**City of Bellevue
Development Services Department
Land Use Division Staff Report**

Proposal Name: Holler Preliminary Short Plat

File Number: 09-113393-LN

Department Decision: Approval with Conditions

Figure 1 – Preliminary Short Plat Site Plan

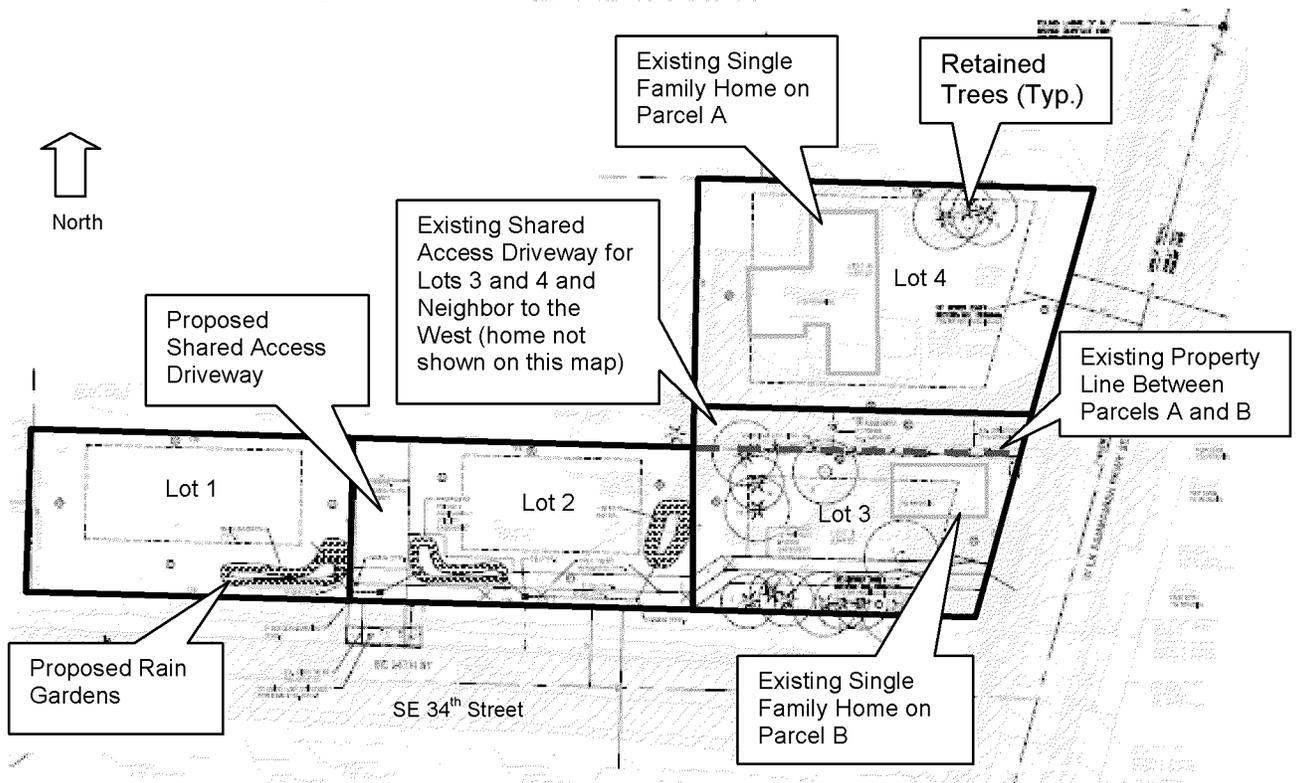
Access to proposed Lots 1 and 2 shall be from a new joint use driveway off of SE 34th Street (as shown on preliminary short plat plans submitted May 12, 2009). Access to proposed Lots 3 and 4 will be from two separate driveways off of West Lake Sammamish Parkway SE as designed per city project CIP PW-R-141. No other access connection to city right-of-way is authorized.

The joint use driveway width for Lots 1 and 2 will be a minimum of sixteen feet dependent upon final approval by the Fire Department (they may require additional width). All driveway designs shall be per the City’s Transportation Department Design Manual Standard Drawing DEV-7A.

Existing access for Lots 1 and 2 (on West Lake Sammamish Parkway SE) are closer than the recommended clear distance from the nearest parallel street (SE 34th Street) as specified in BCC 14.60.150.K (150 feet). The code does allow for reduction of the 150 foot clear distance due to restricting site conditions. For the Holler Short Plat, restricting site conditions include steep grades and a short length of frontage on West Lake Sammamish Parkway SE (approx. 160 feet). In addition, the design of city project PW-R-141 will greatly enhance safety conditions involving the ingress and egress from lots 3 and 4 with traffic on the adjacent streets by signaling the intersection of SE 34th Street and Lake Sammamish Parkway SE.

Access for proposed Lots 1 and 2 on SE 34th Street meet all transportation code requirements.

- a) The tall shrub hedge planted for screening along the western property line of proposed Lot 1.
- b) The three proposed rain gardens on proposed Lots 1 and 2.

The applicant shall relocate the existing shed on proposed Lot 2 on to proposed Lot 3. The new location shall be in conformance with the requirements for detached accessory structures and applicable setbacks for R-5 lots.

The landscape screening, shown on the preliminary short plat along the western property line, shall be installed per the submitted Landscape Plan during plat engineering and prior to issuance of the Final Short Plat.

Figure 5 – Street Frontage Improvements for CIP DW-R-141

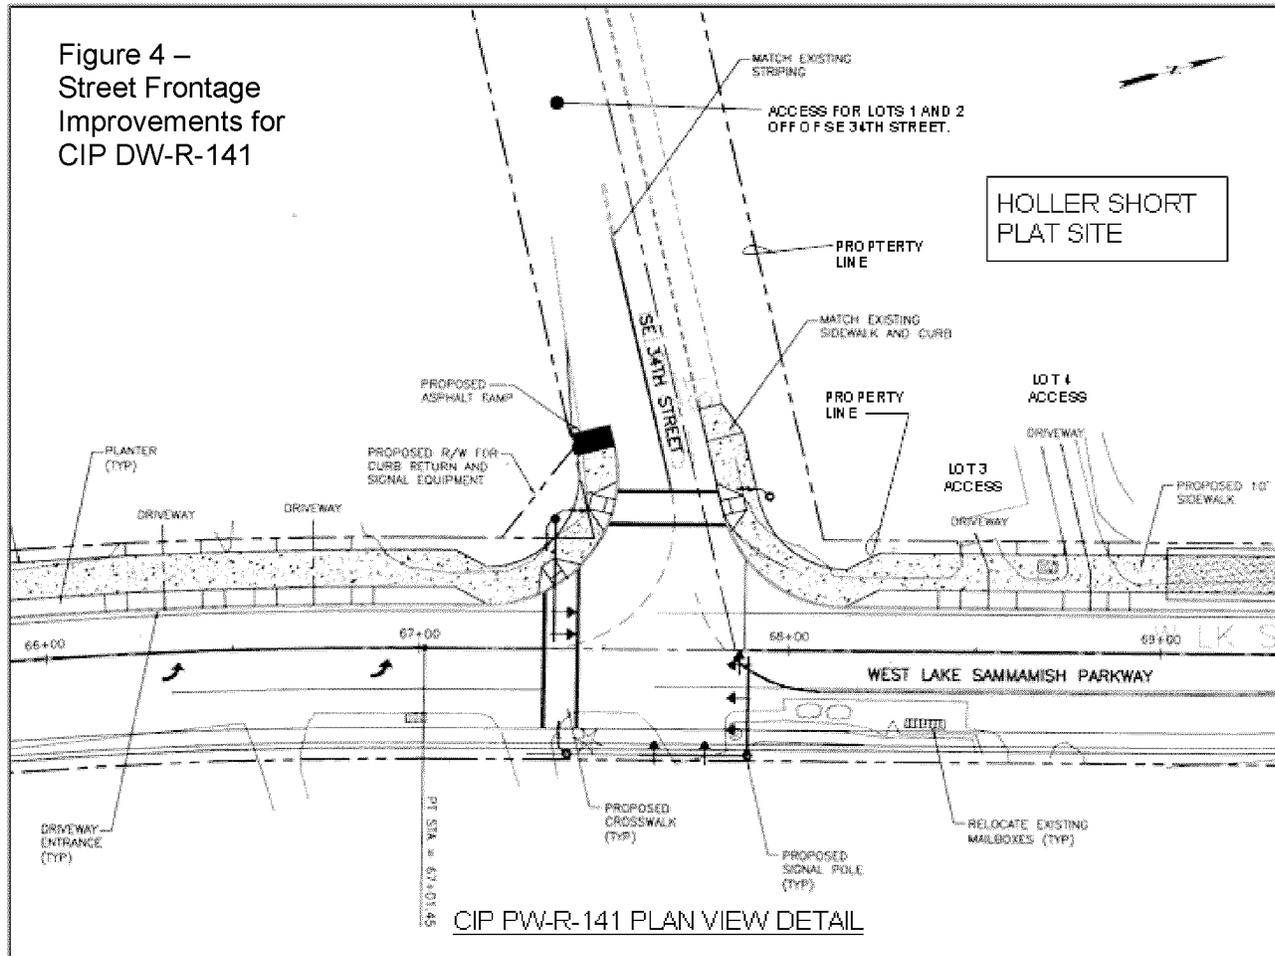
BCC section 14.60.110.B states “Complete street frontage improvements shall be installed along the entire street frontage of the property at the sole cost of the permittee as directed by the Review Engineer. Street frontage improvements may include curb, gutter, sidewalk, storm drainage, street lighting, traffic signal equipment, utility installation or relocation, landscaping strip, street trees and landscaping irrigation, street widening, and channelization.”

Per BCC section 14.60.110.C, the City will require payment to city project CIP PW-R-141 in lieu of actual construction of required frontage improvements on West Lake Sammamish Parkway and SE 34th Street as shown below. (Required frontage improvements consist of all improvements adjacent to the project site's property lines). The applicant will be responsible for all damage to city infrastructure caused by construction activity related to this development. **Refer to Condition of Approval regarding engineering plans and infrastructure improvements in Section V of this report.**

A site (civil engineering) plan produced by a qualified engineer must be approved by the City prior to clear and grading permit approval. The plan must make reference to CIP PW-R-141 for required street frontage improvements as shown section V.C. (Street Frontage Improvements) of this report. The applicant shall obtain the most update design drawings for PW-R-141 (as it relates to the Holler Short Plat) and include them in the clear and grade plan set. Also, the plans must show the joint use driveway for Lots 1 and 2 per DEV-7A and any anticipated pavement restoration.

- a) Submittal of \$12,000 dollars to the project fund of CIP PW-R-141.
- b) Construction of a joint use driveway for lots 1 and 2 per DEV-7A on SE 34th Street.
